# Staff Summary Report

**SUBJECT:** Hold a public meeting for a Development Plan Review for O'REILLY AUTO PARTS, located at 620 E Southern Ave.

DPR12138 – Development Plan Review including site plan, building elevations, and landscape plan.

LANDSCAPE PLAN  
L1 of 3

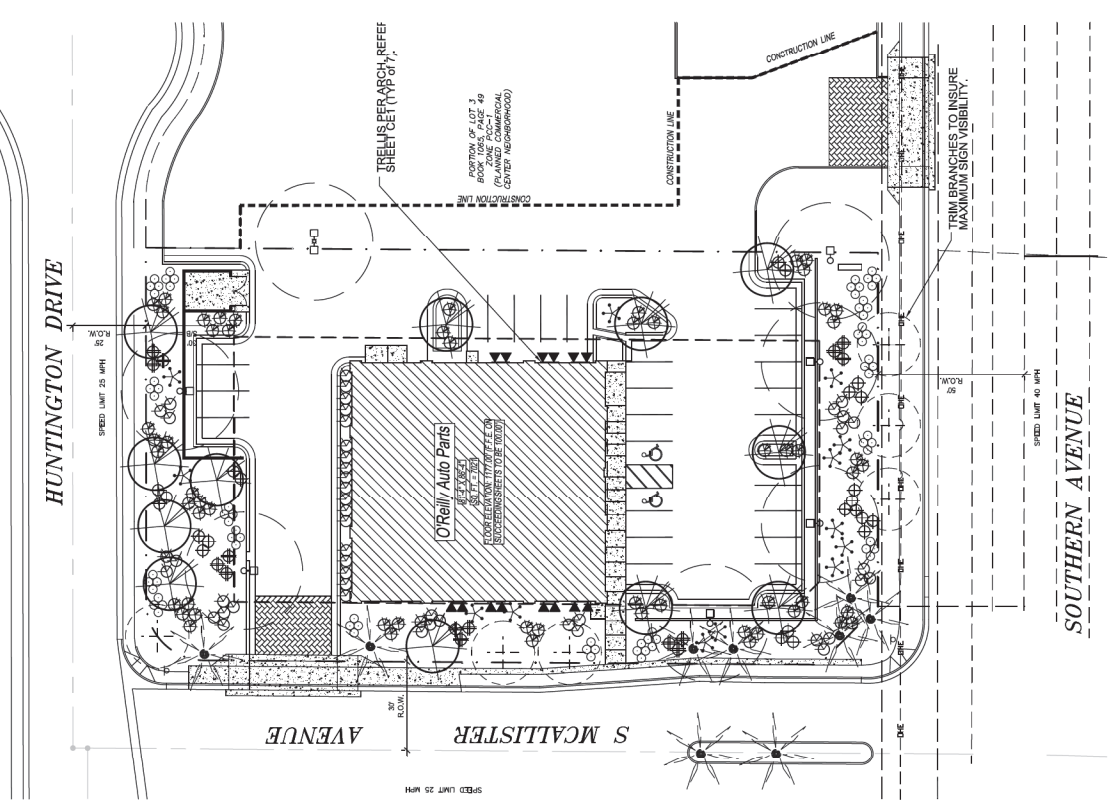
- c. Required trees shall comply with minimum code size requirements of 1 ½" caliper trunks.
  - d. Sheet L1 - pink trumpet vines for the green screen trellises shall be used on all trellises (the north west side of the building did not have symbols on the plan),

1 SITE LIGHTING PLAN  
SL2 SCALE: 1"=20'

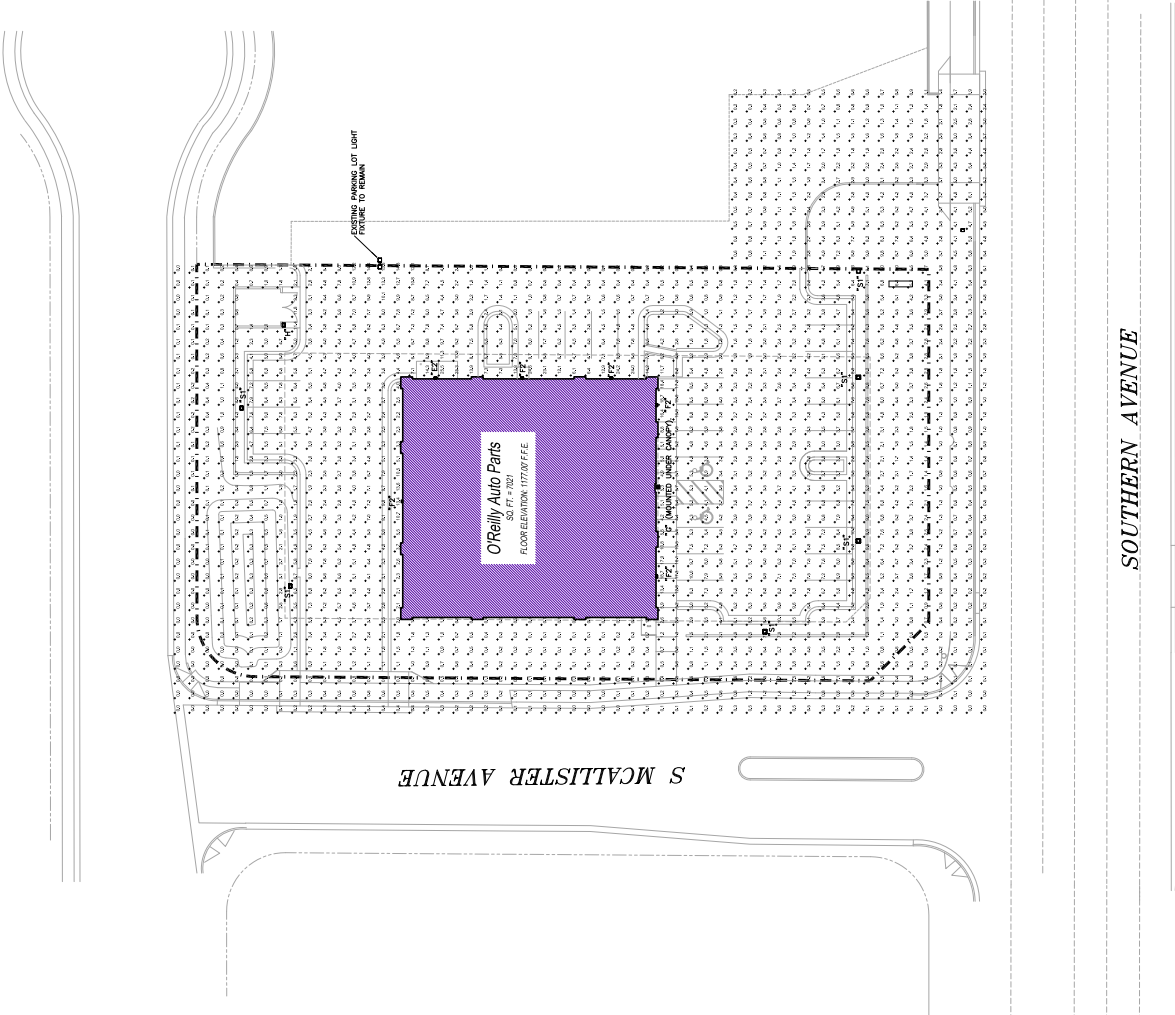
13. Coordinate lighting locations on sheets CE 1 (color rendering), A3 and SL 2.

14. This project shall follow requirements of ZDC Part 4, Chapter 8, Lighting, unless otherwise conditioned.
15. Illuminate building entrances from dusk to dawn.
16. Reduce light levels on north side of building to comply with code for refuse (5 fc), parking (2 fc), retention (.5 fc) and drive aisle (1 fc) and not to exceed required levels by more than 50% or as deemed appropriate by plan check staff during building permit submittal.
17. Provide one wall pack light centered on west elevation to more evenly distribute light around the building and provide more pedestrian illumination along McAllister.
